30/13-00B 4710 Waverly Avenue  
(Garrett Park Historic)

## Changes to Plans for

4710 Waverly Avenue, Garrett Park, MD, 20896-0424

Permit Number: 232765

**FRONT ELEVATION**  
1/4" = 1'-0"

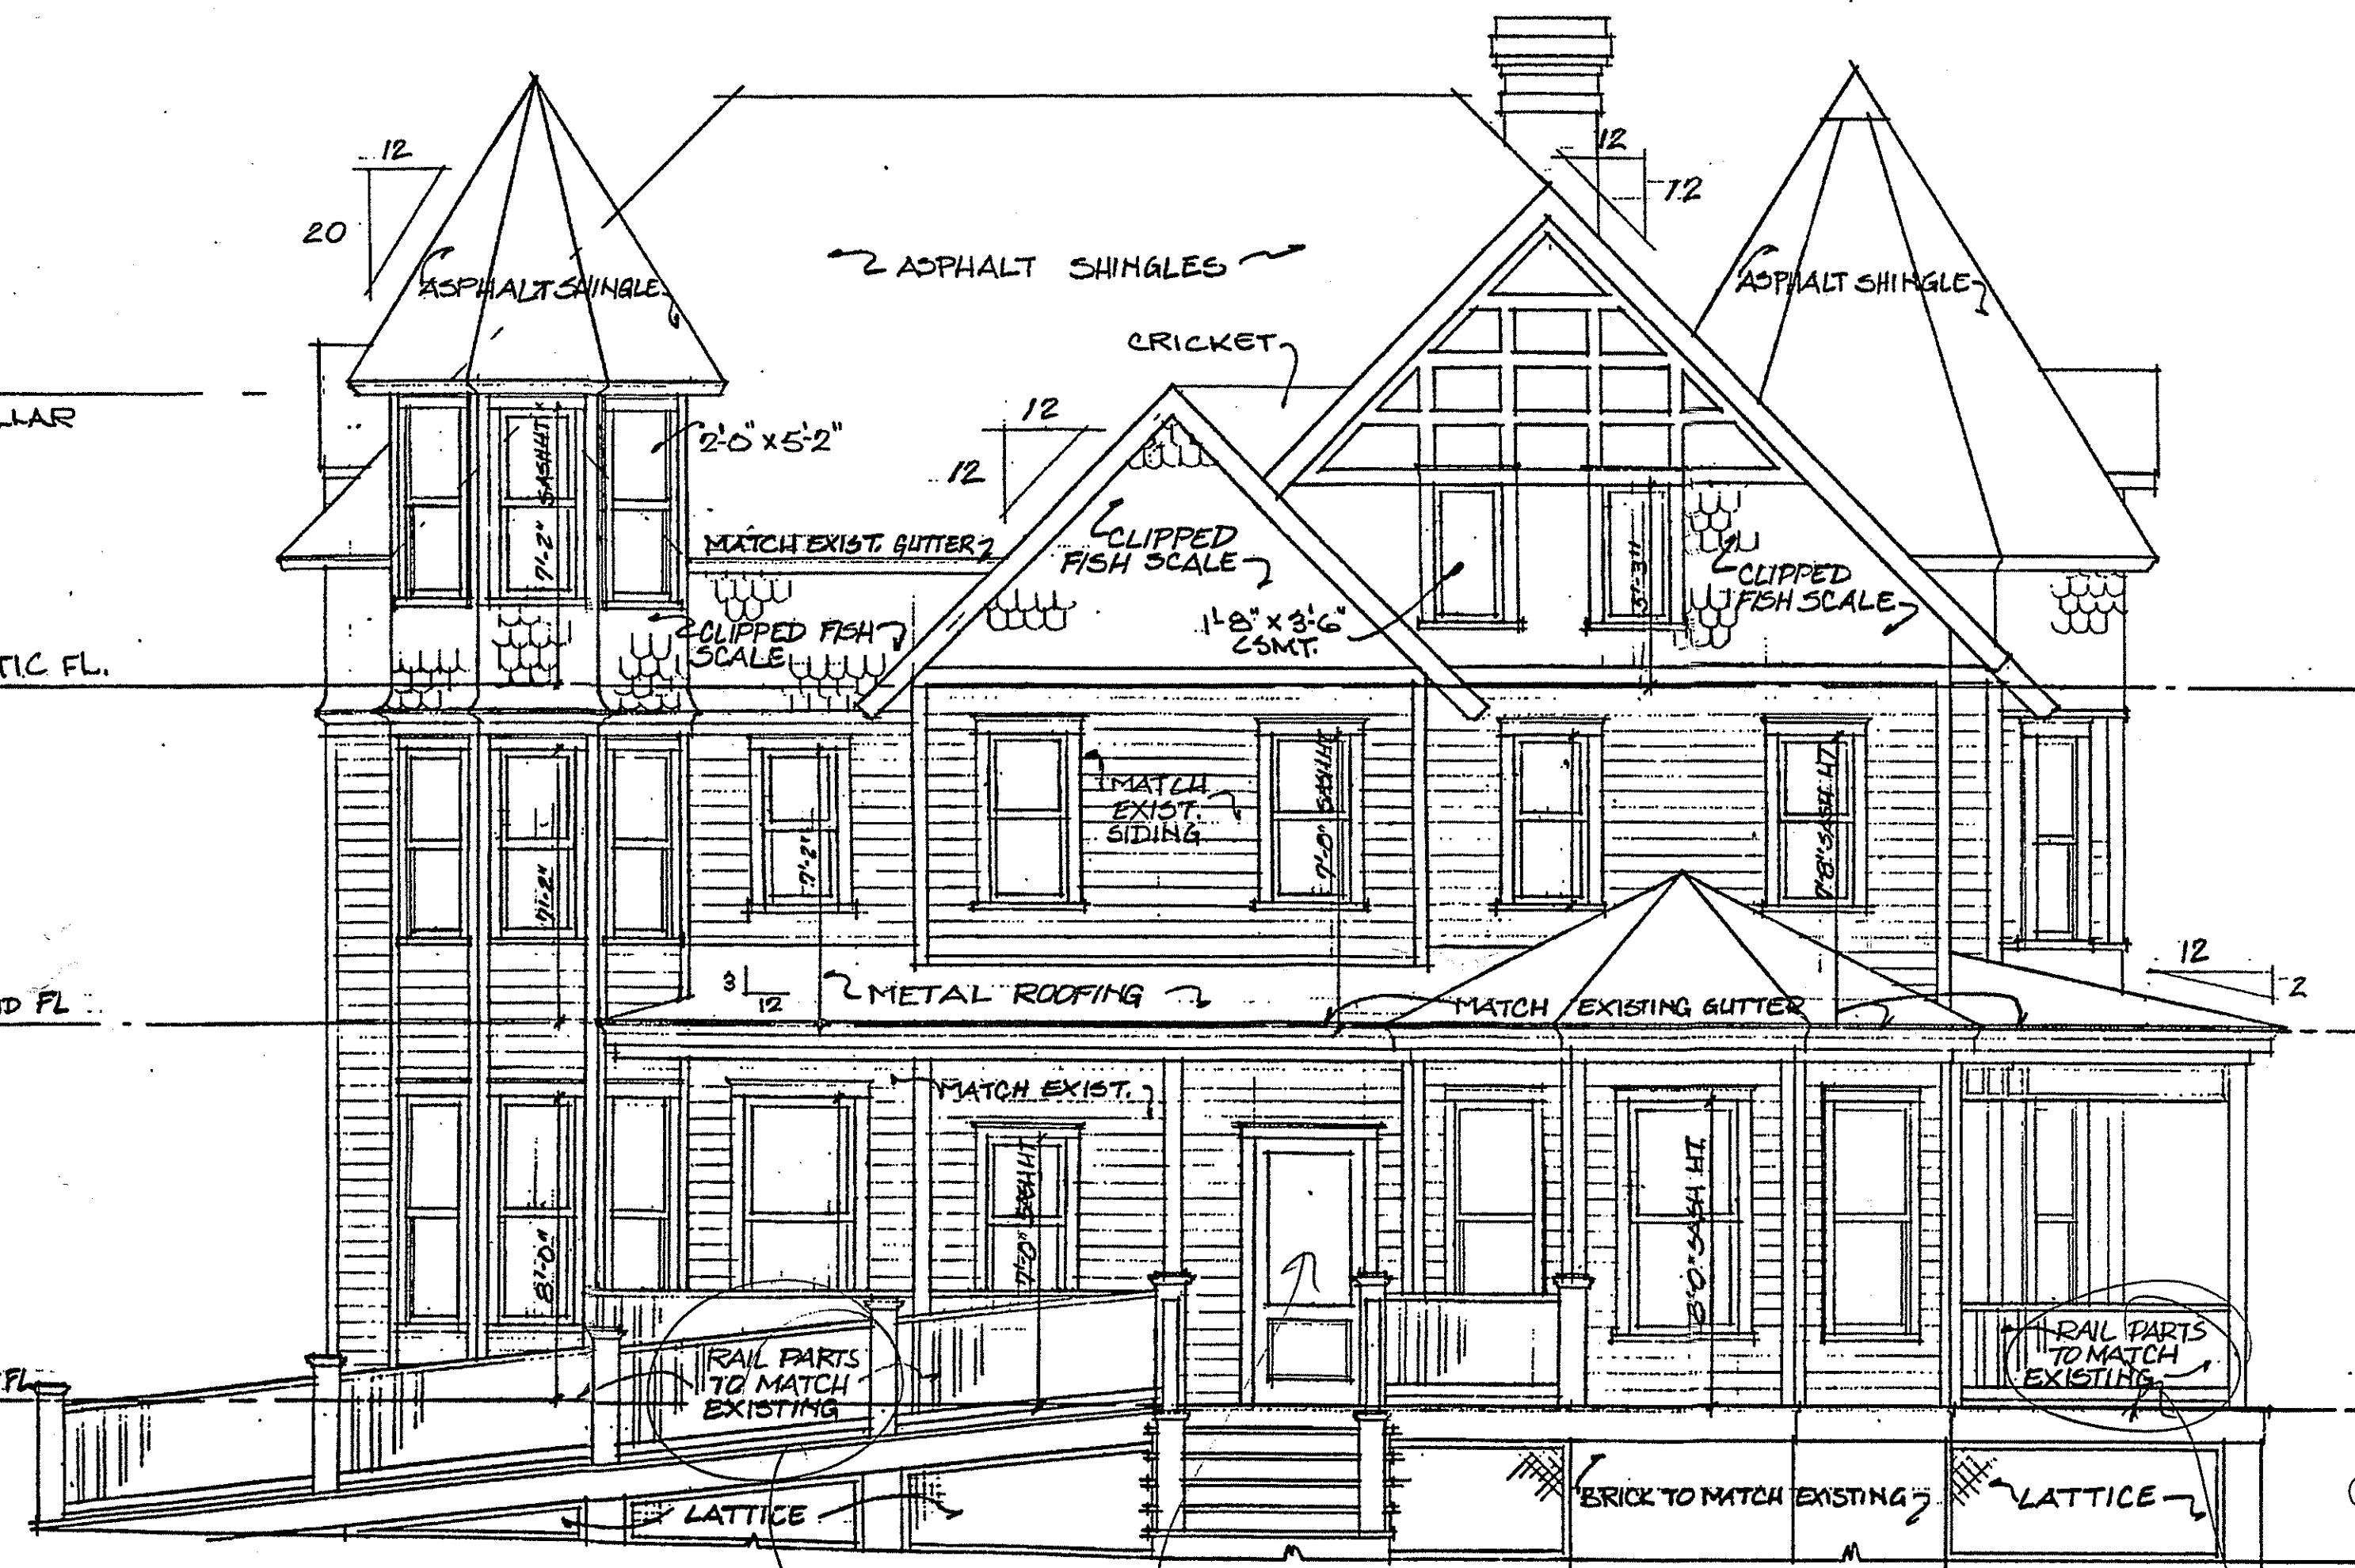
2. **Drawings 1 and 2. Basement, First and Second Floor Plans:** Removed elevator shaft. Moved staircase to rear of house.
3. **Drawings 2, 3 and 4. First Floor Plan and Front and Right Elevations:** Removed bathroom and corrected omission by architect of entrance hall off porch joining old house to new house.

③ corrected omission of entrance hall off porch joining rooms

RIGHT SIDE  
1/4" = 1'-0"

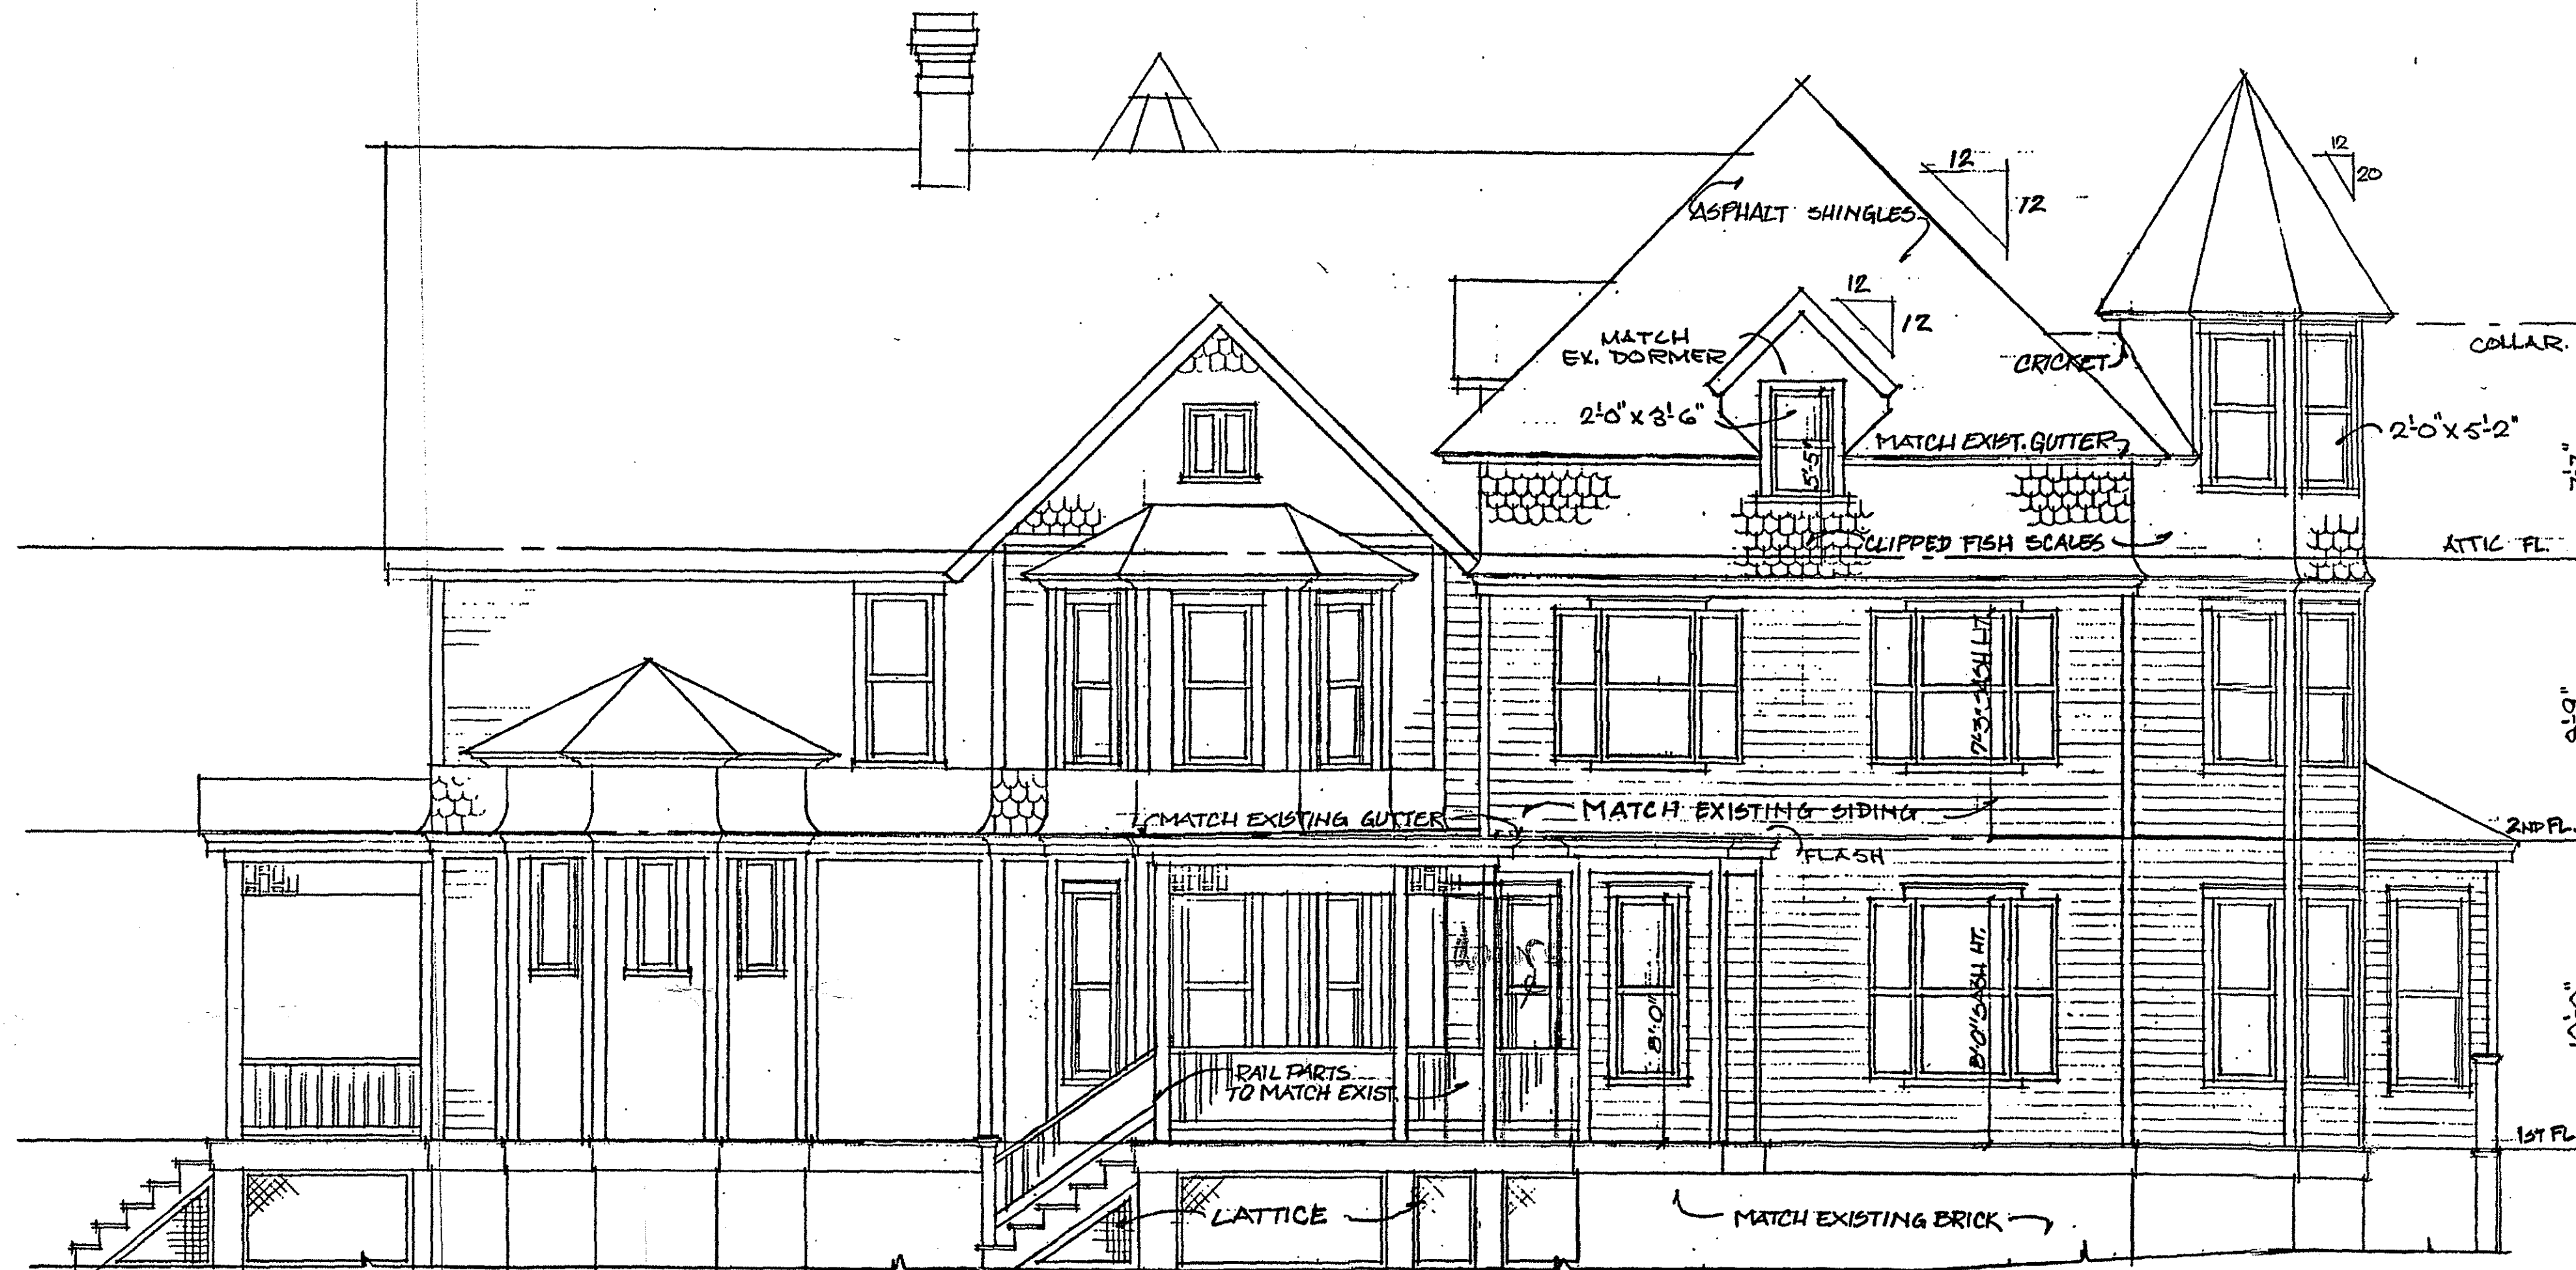
③ Corrected omission of entrance hall off porch

**ROOFING PLAN**

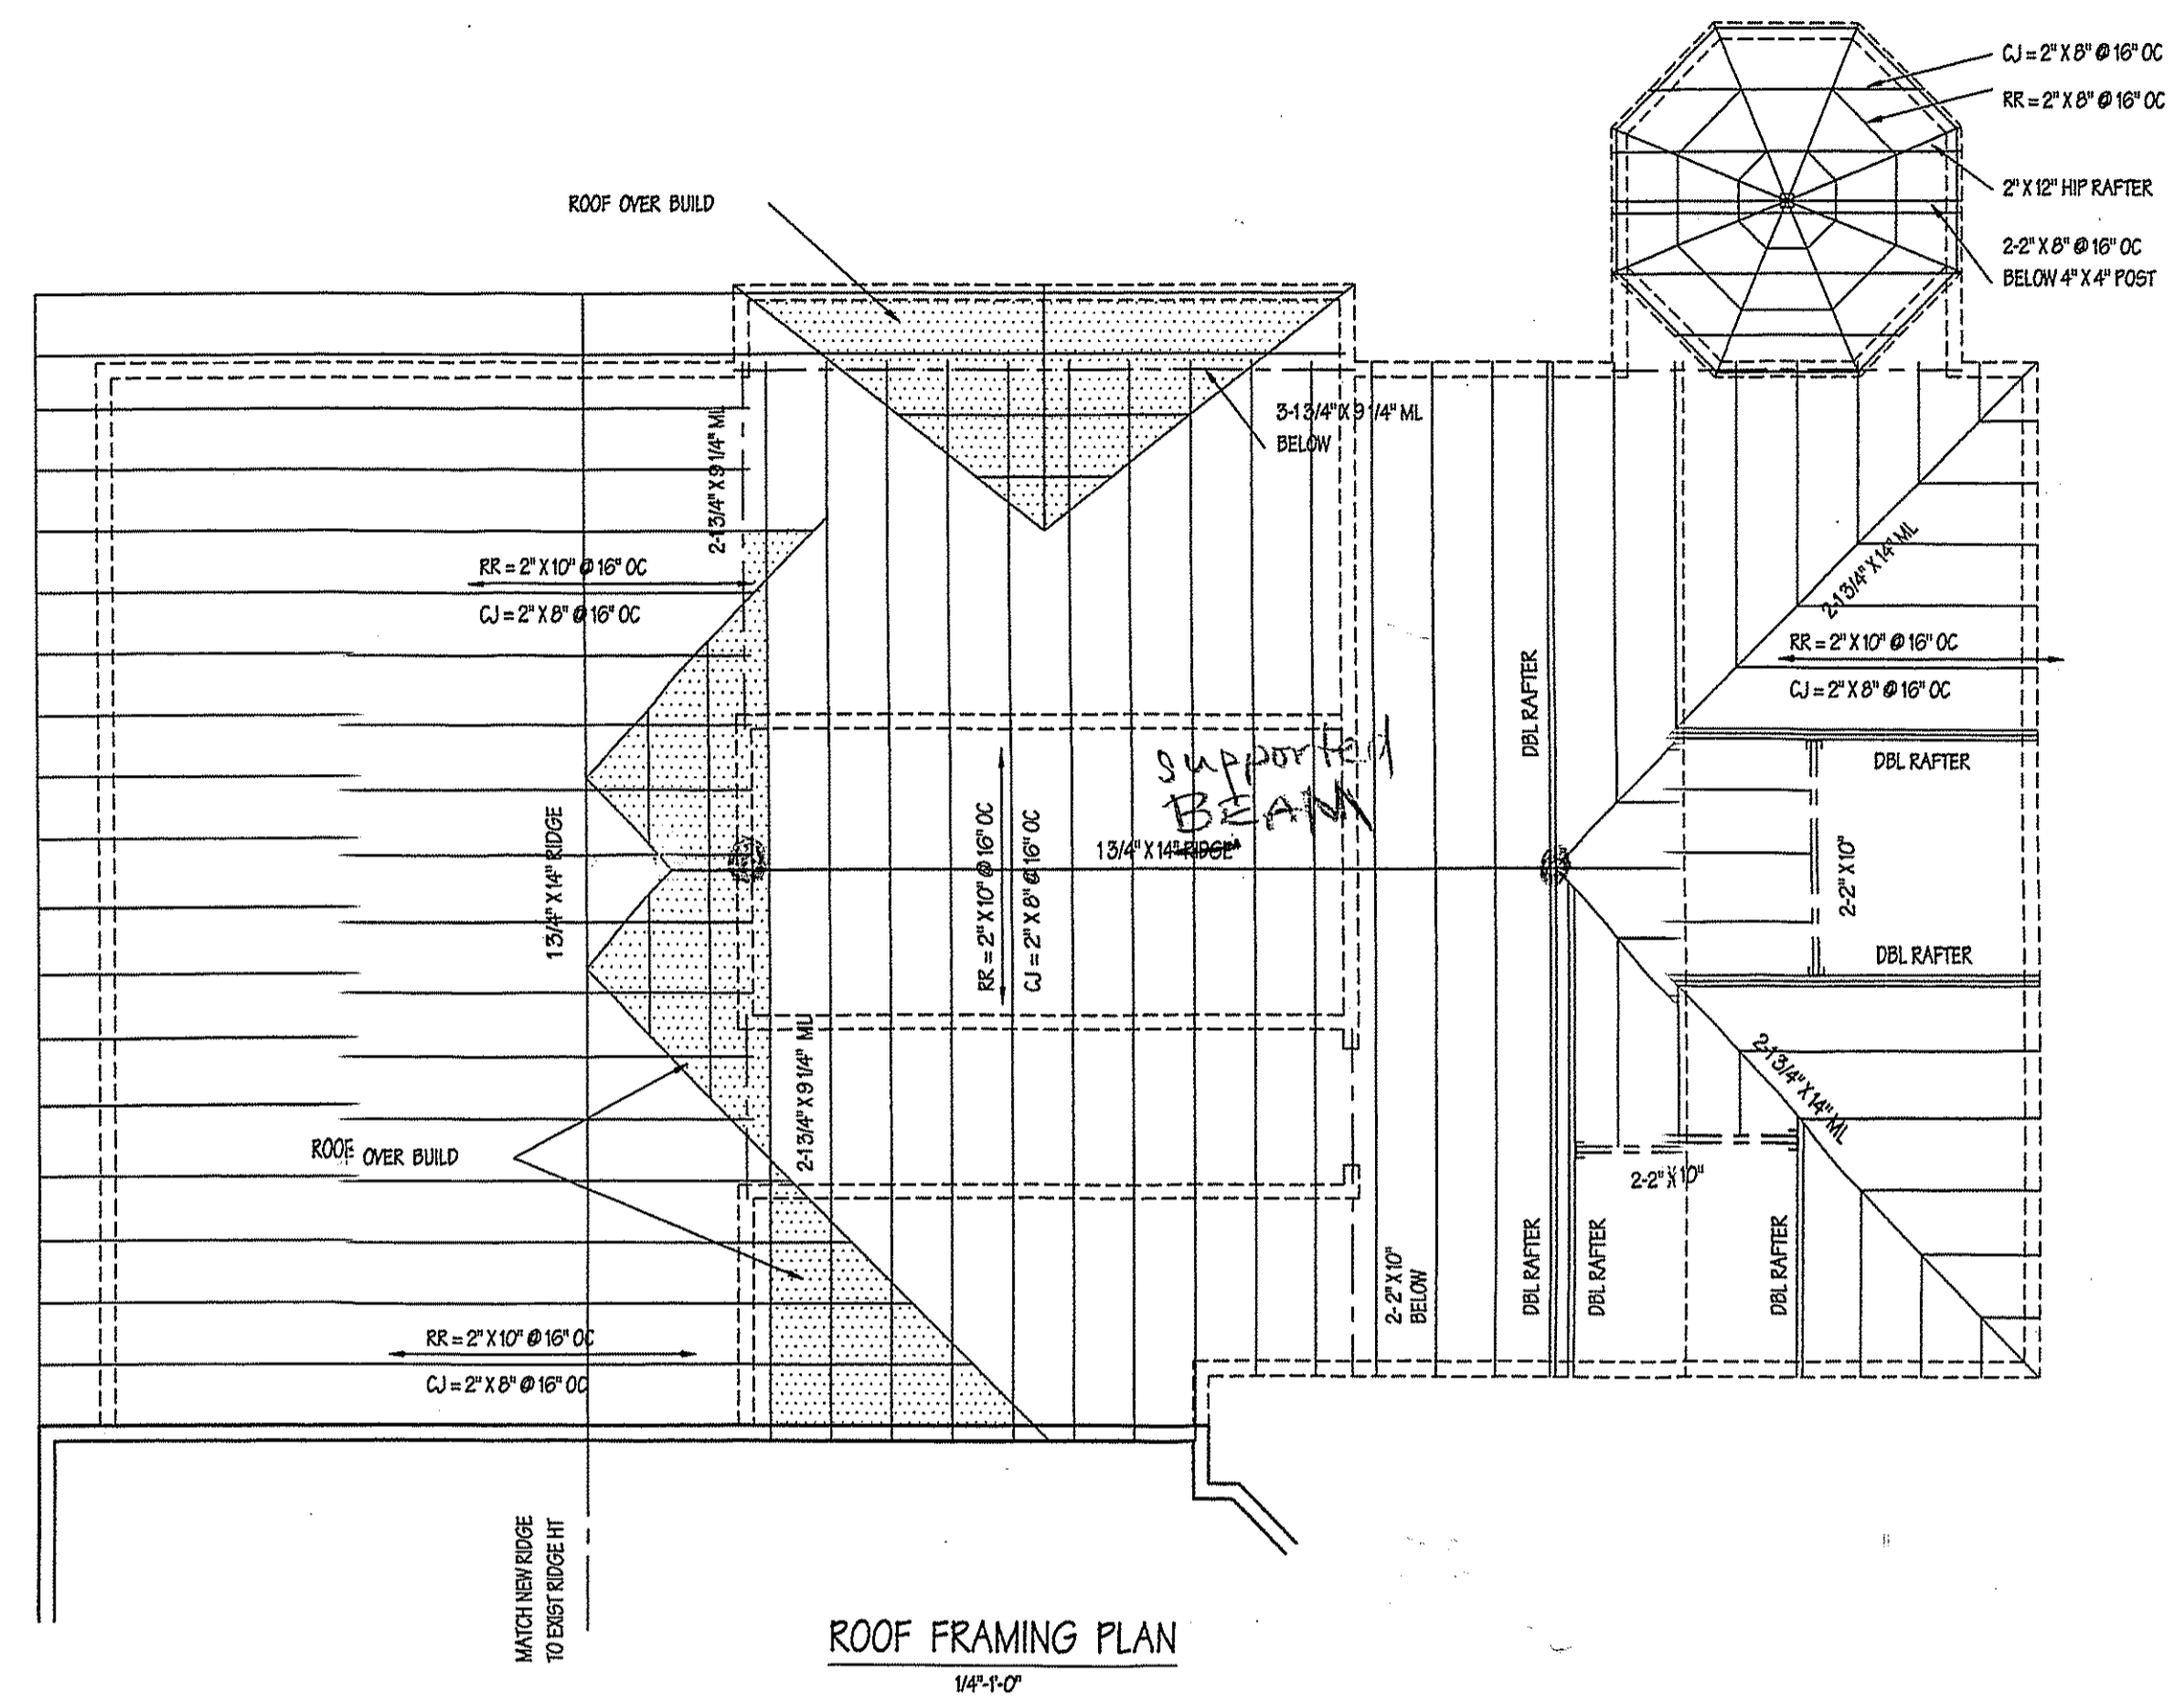
4. **Drawing 2. First Floor Plan:** Moved bathroom to pantry area (left side of first floor plan).
5. **Drawings 6, 7 and 7a. Structure, Third Floor and Roofing Plans:** The architect's roof plan was incorrect. The ridge plate should not have been used with the knee wall, which began to move. The structural engineer from Jolles and McKenzie visited the site and established revised structural plan for a supported roof beam with supports down to the footings in the basement floor (drawing dated January 4, 2002).

See revised sheet # 7A (attached)  
 (CM)
